**COMMONWEALTH OF KENTUCKY
BEFORE THE KENTUCKY STATE BOARD
ON ELECTRIC GENERATION AND TRANSMISSION SITING**

**ELECTRONIC APPLICATION OF ASHWOOD)
SOLAR I, LLC FOR A CERTIFICATE OF)
CONSTRUCTION FOR AN APPROXIMATELY)
86 MEGAWATT MERCHANT ELECTRIC) Case No. 2020-00280
SOLAR GENERATING FACILITY IN LYON)
COUNTY, KENTUCKY PURSUANT TO KRS)
278.700 AND 807 KAR 5:110)**

CASE NO. 2020-00206
ASHWOOD SOLAR, LLC
RESPONSES TO SITING BOARD'S SECOND REQUEST FOR INFORMATION

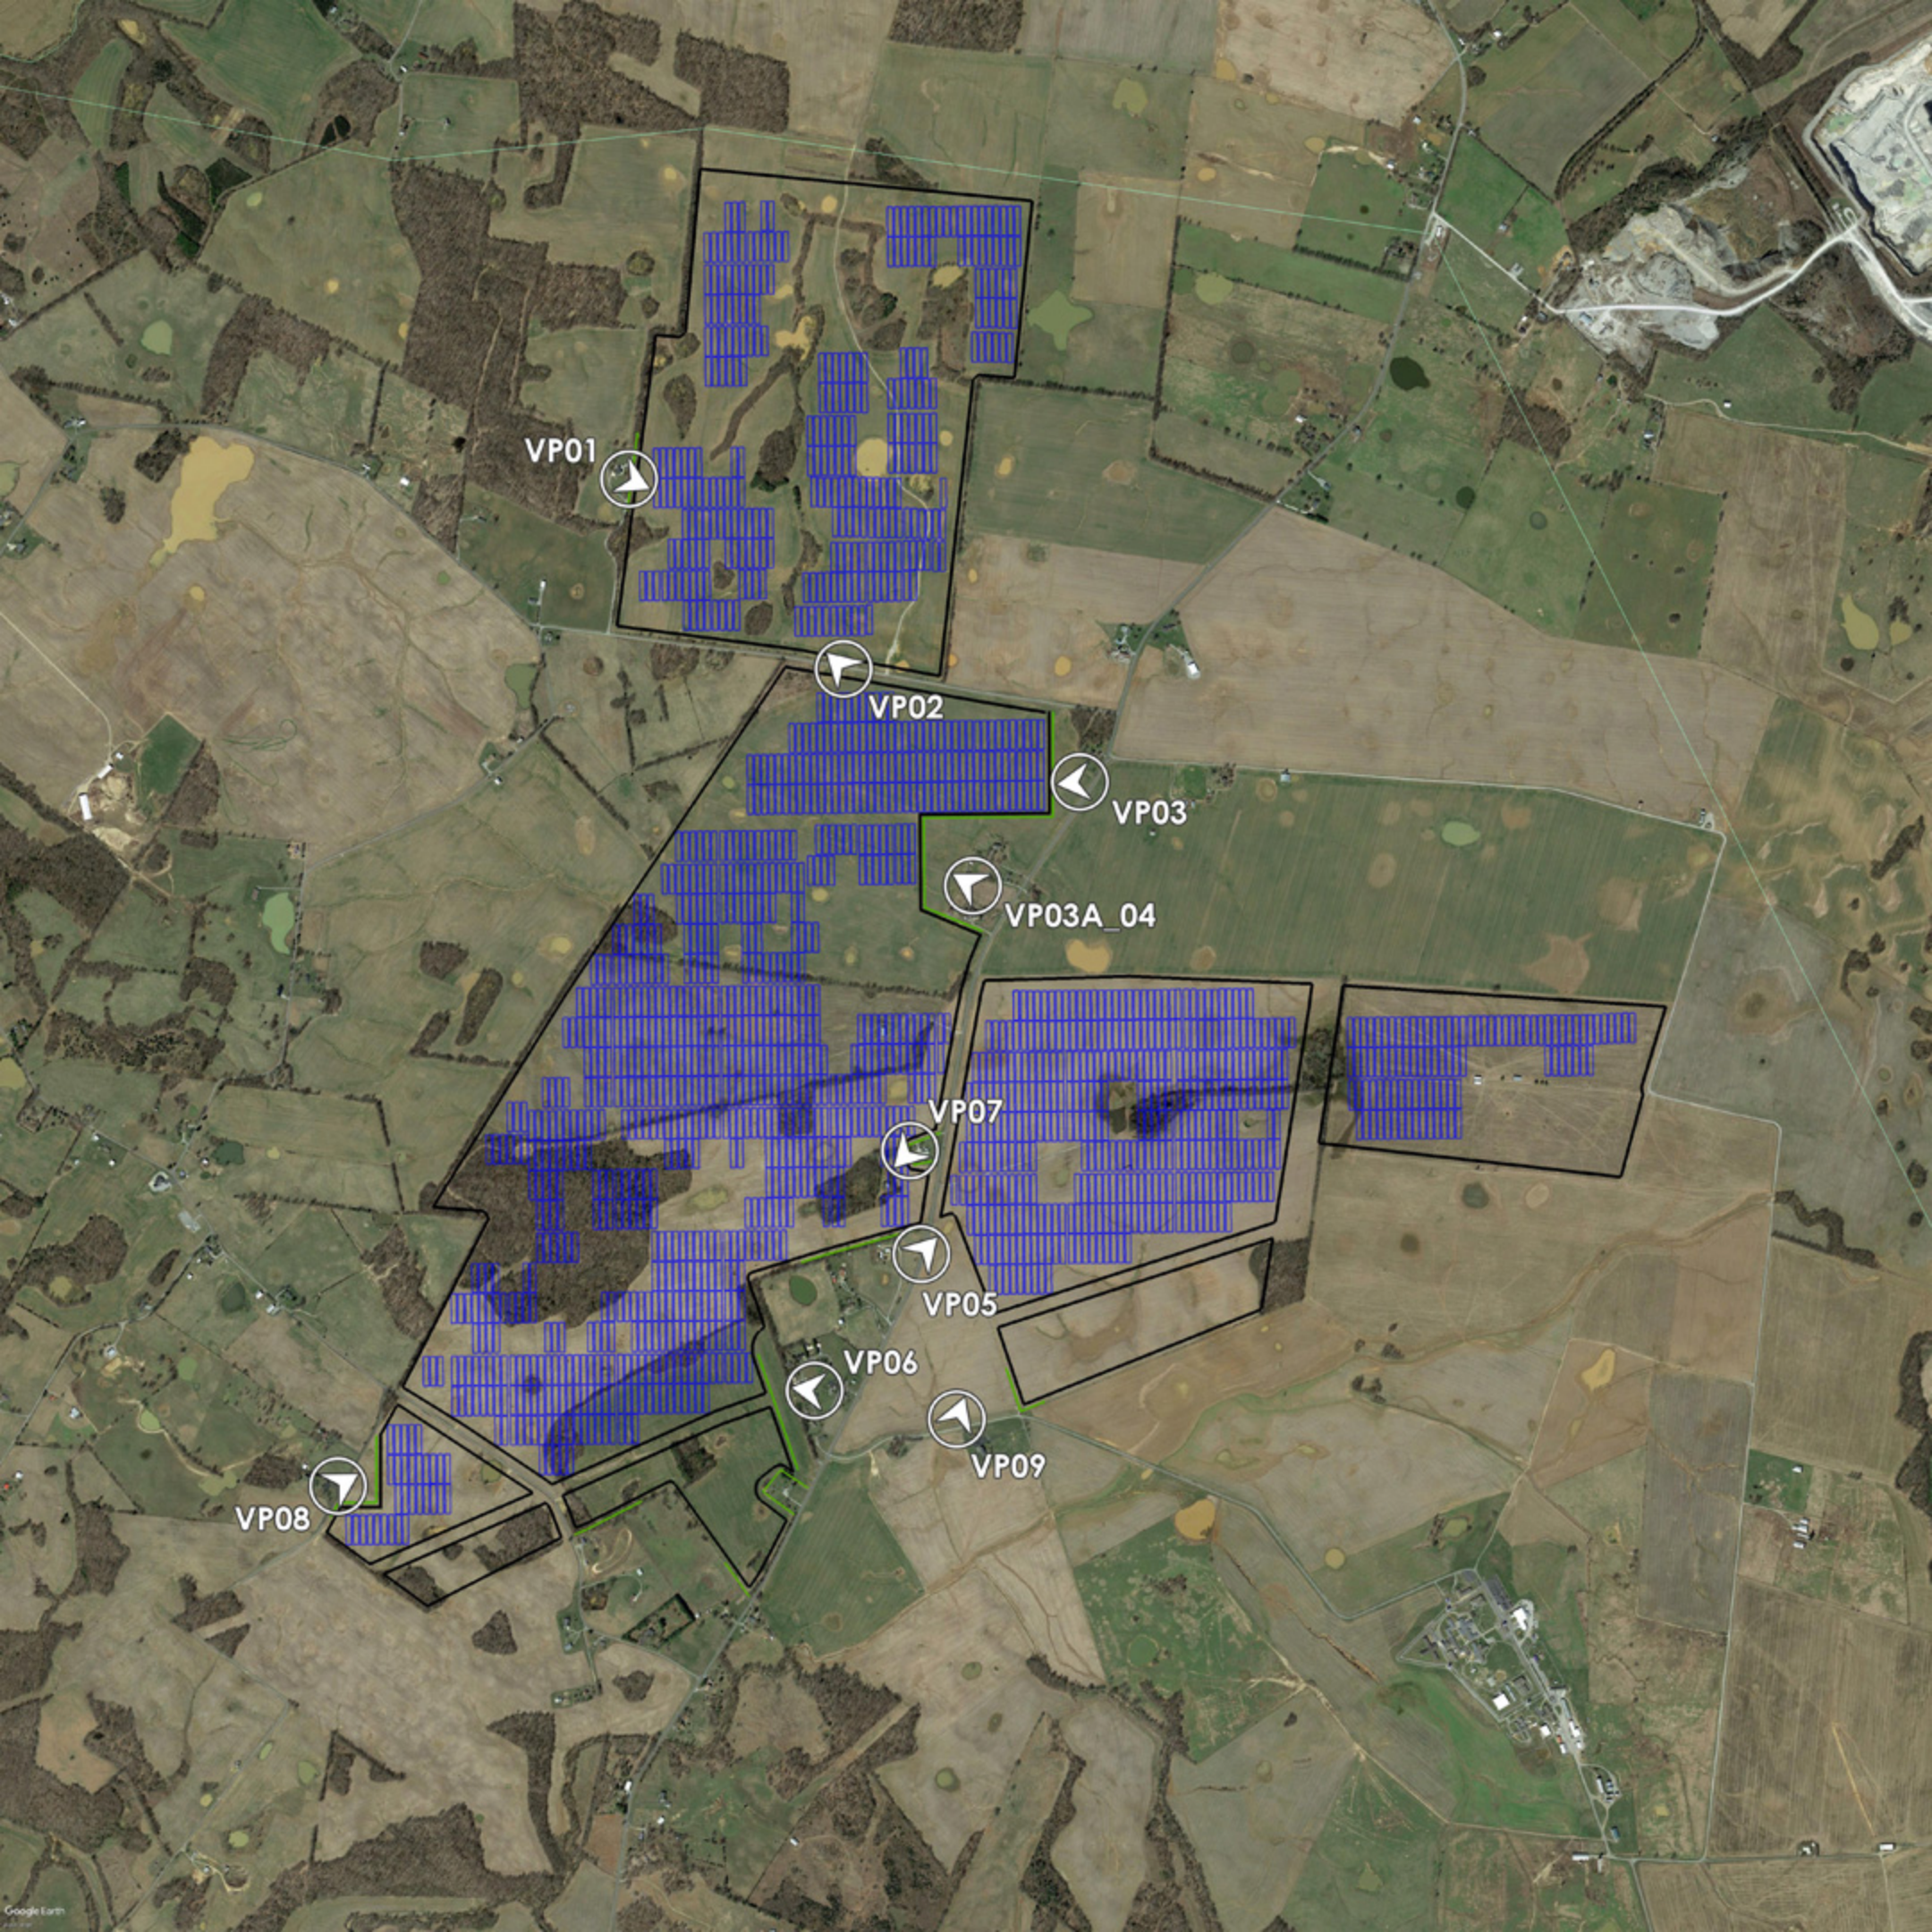
6. Refer to the map attached to the Appendix. There are four locations circled in this map, which reflects the southern portion of the proposed solar facility site. Property owners in these four locations have expressed concerns about the close proximity of the solar panels to their respective properties and have inquired whether the panels could be located further away from their property. With respect to these four areas, state the expected distance of these properties from the solar panels and whether the panels can be moved to mitigate any viewshed impacts to these four properties.

Response: The distances to these four areas are as follows:

- **Residence on the southwestern edge of the project 217 feet from the nearest proposed panel**
- **Residence on the Northwestern edge of the project 300 feet from the nearest proposed panel**
- **Northern most residence on highway 641 327 feet from the nearest proposed panel**
- **Two residences in the middle of the project area are 126 and 219 feet from the nearest proposed panel**

All of these distances are depicted in the enclosed map.

Since Ashwood has not finalized final engineering and design for the project portions of the panels located in close proximity to the four areas depicted in the map could be potentially relocated, dependent on constraints within the remainder of the site and if the relocation/removal of panels is practicable and economically viable. Further, to
